Shop Drawing Submittal Review

Project Name: Webster University-**ISB**

Copies	No.	Description
1 PDF	211313F02	(Submittal No.'s:)
		(Cannon #211313-015) - (Paric #15051-0349) - (WES #607)
		➤ Wet Pipe Sprinkler System Product Data

PROJECT NAME: Webster University I
LOCATION: St. Louis Missouri
CLIENT PROJ. NO.: N/A
WES PROJ. NO.: 607
SPECIFICATION SECTION: 211313
Wet Pipe Sprinkler
System
SUBMITTAL ITEM: See Below -

Bells Dimensions Inches (mm)

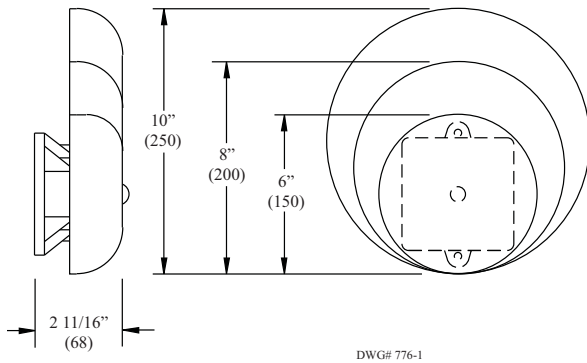
Specified to be 10 inch diameter. Refer to specification section 211313, part 2.6, B4.
